SUBJECT: Site Plan Review for 80 Ravenna Street –
 Founders Lane Single Family Attached Development

PC Case No: 2015-29

Re: **Founder's Lane (Private) Improvement Engineering Dept. Plan Review**

FOUNDERS LANE (PRIVATE) PLAN and PROFILE 4/7

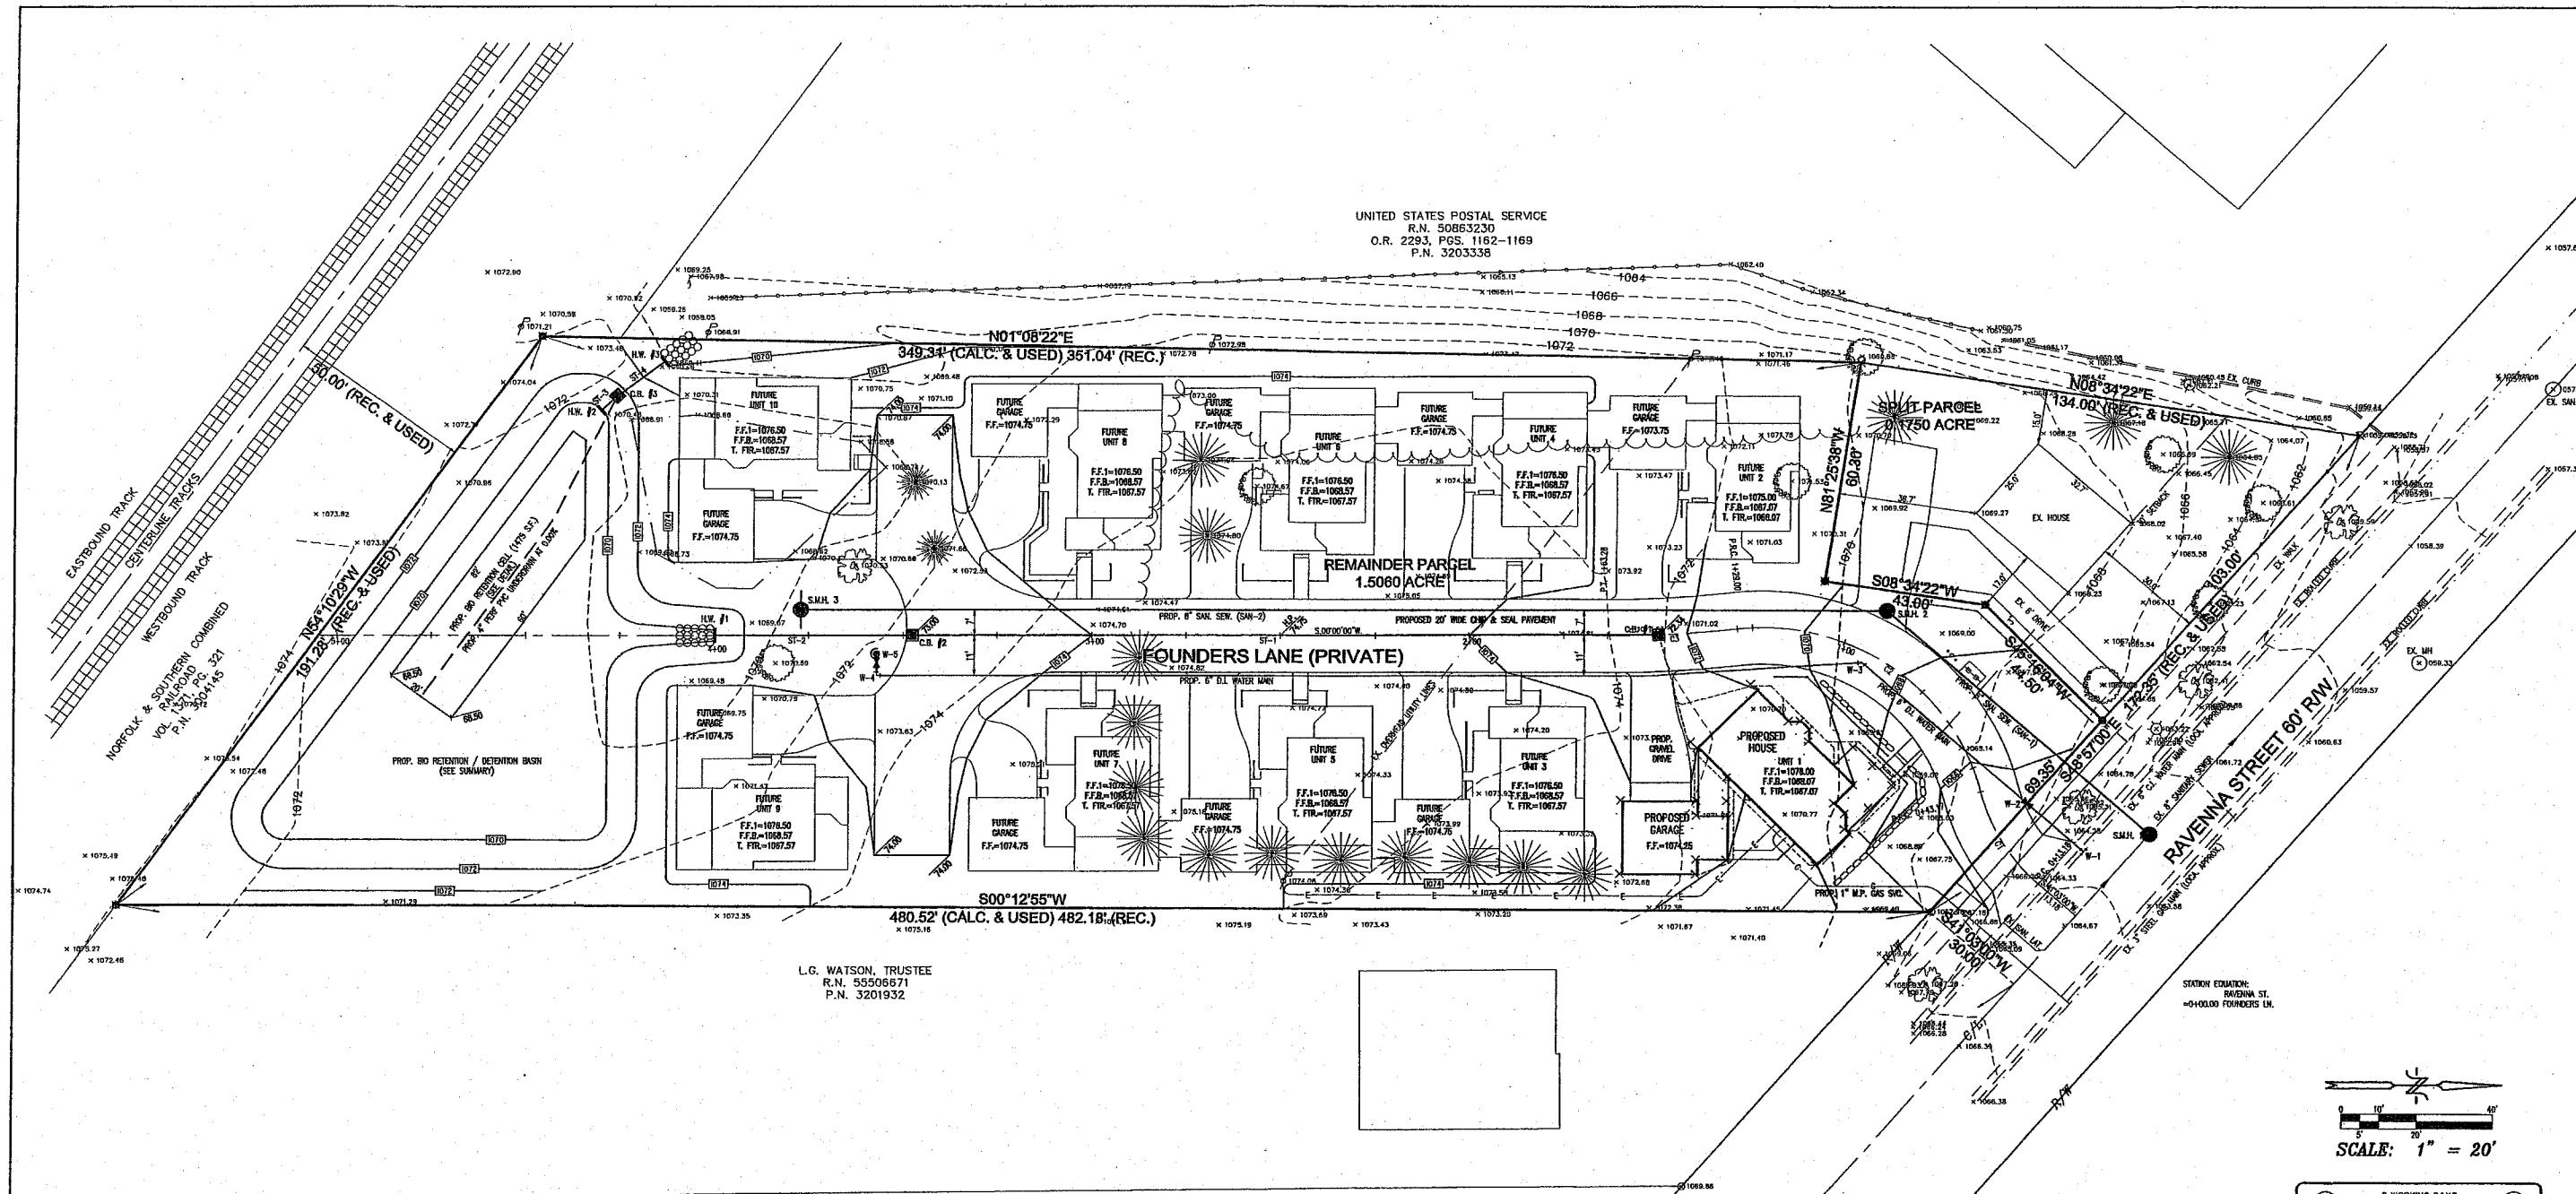
1. Maintenance of traffic plan per the Hudson Engineering Standards shall be submitted to the City for all of the proposed work within the R/W. (Add a note: No staging of equipment, materials, shall be within the City of Hudson R/W without prior written consent from the City.)
2. All open-cut work shall be road plated (90,000# truck loading) with advance warning signs of the plate installation for the traveling public. The plate edges shall be cold patched and the plate spiked to the existing roadway. Restoration per Hudson Engineering Standards of the roadway shall be within 14 calendar days of the road opening. During inclement weather, a concrete cap shall be installed and removed when the asphalt plants reopen in the spring (See note 4 below)

4. During the months of December thru April, a concrete caps shall be used and asphalt will need to be installed by the contractor in the spring after the asphalt plants reopen. A separate maintenance of traffic and separate notification will be required for this.

7. The utility service lines for sanitary, storm and water within the property boundaries up to the edge of the public road pavement (or curb box for water) are private and the lines within the Ravenna Street roadway are public. Please note private or public on the plan sheets. (Note: This is Roadway, not R/W)

8. Show the individual service connections (i.e. storm, electric, sanitary and water) at each unit. An Electrical Plan will be needed for Hudson Public Power to approve.

9. Note: The City of Hudson will be transitioning ownership of the sanitary sewer system in Hudson to the Summit County Department of Environmental Services on January 1, 2016. Plans shall be submitted to Summit County concurrently with the City to ensure compliance with both entities.

15. A plat note will needed added in accordance with the Hudson Land Development Code indicating that the pond maintenance is the responsibility of the landowner and/or homeowners association, however, the City reserves the right to access and maintain if necessary. See Reference LDC Section 1207.07-d-5 for the exact wording.

16. Please respond if the pond is a retention pond or detention pond. The plans show a ws elevation and a underdrain pipe?

Landscape Plan

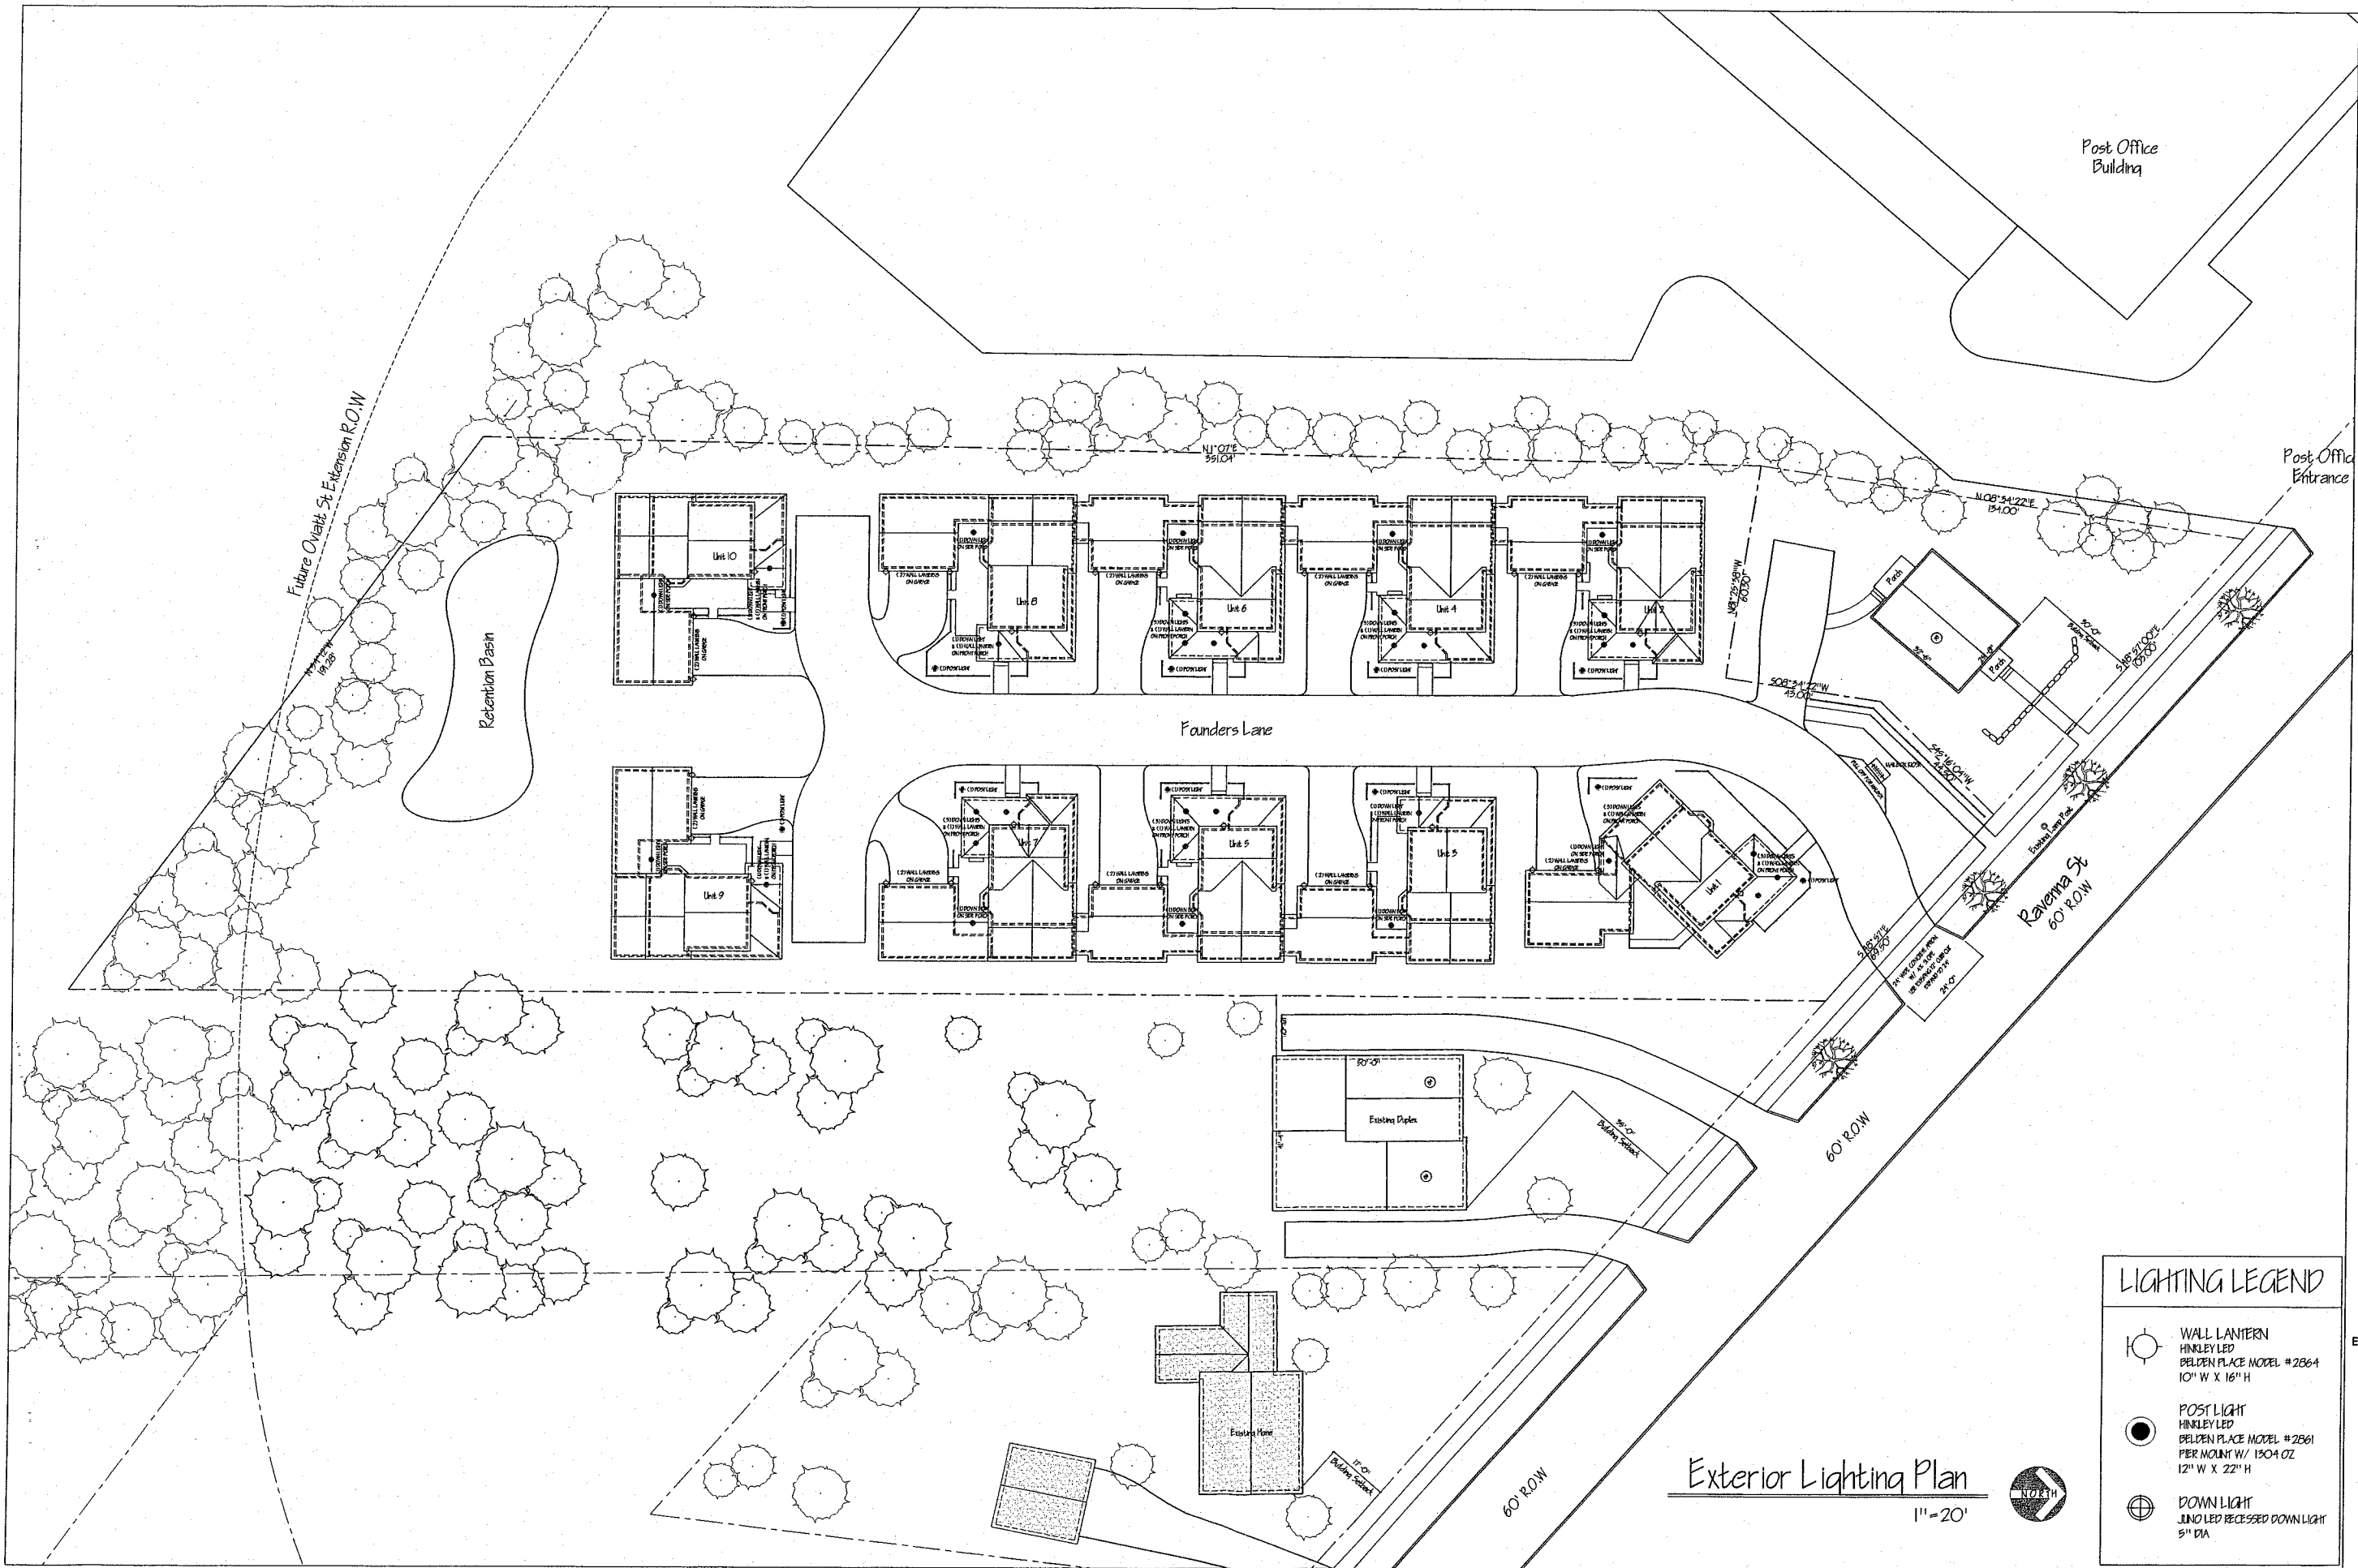
Bufferyard B (10 ft) is applicable to the adjacent duplex to the east. Bufferyard C (15 ft) is normally applicable to the post office use to the west; however Section 1207.04(e)(4)(B) allows the less intense use to install a minimum Bufferyard B. The submitted 10 foot depth planting area and the density of plantings along both side yards are acceptable. The City Arborist reviewing of the proposed plant selections.

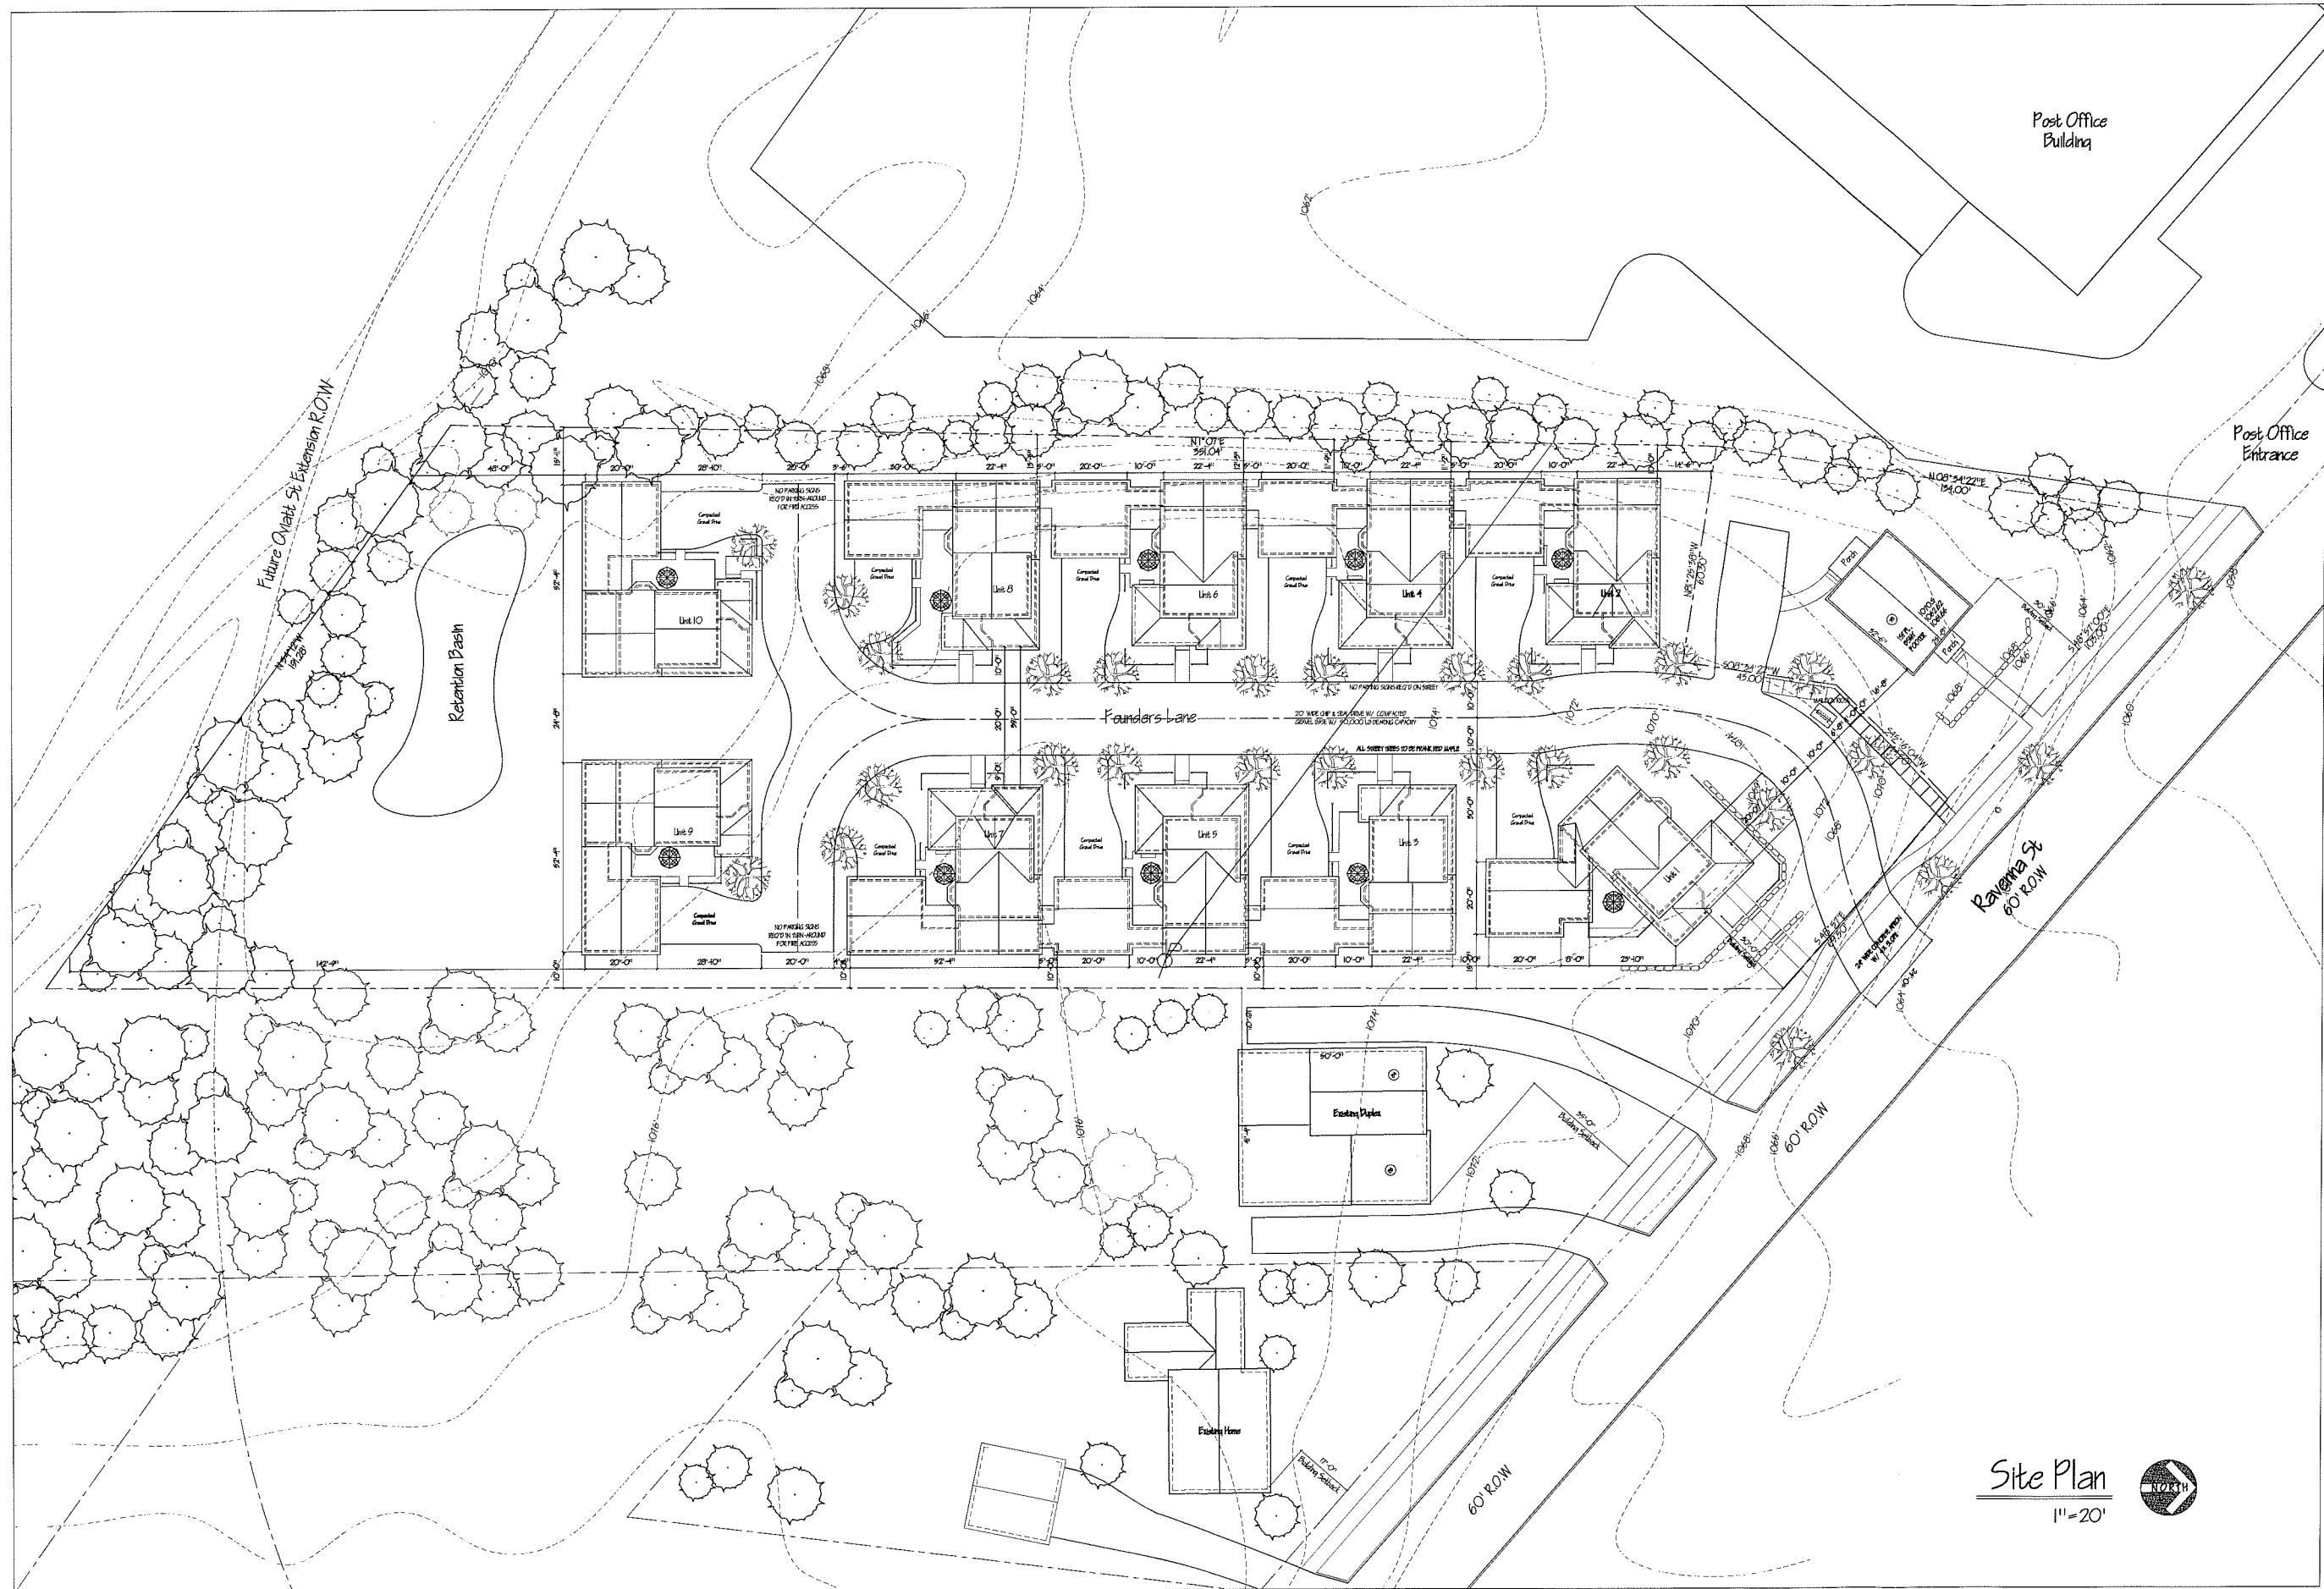
2. Revise the impervious surface coverage table to clearly indicate the pre and post impervious surface coverage.
3. Building Orientation: Flip the garages and the living space for units 9 and 10 so that the porches face Founders Lane.

4. Sidewalks: Incorporate a walkway from the entrance of unit one directly to Ravenna Street.
5. The entrance driveway must meet the required emergency access standards including 20 foot width, turning radius of 20 ft inside and 40 ft outside, 50,000 lb bearing capacity, and a maximum grade of 4%. The plans must be revised to indicate compliance with each of the applicable standards.

7. Relocate the mail kiosk an additional 15 feet to the south so it is located behind the front plane of the street front units and limited in visibility.
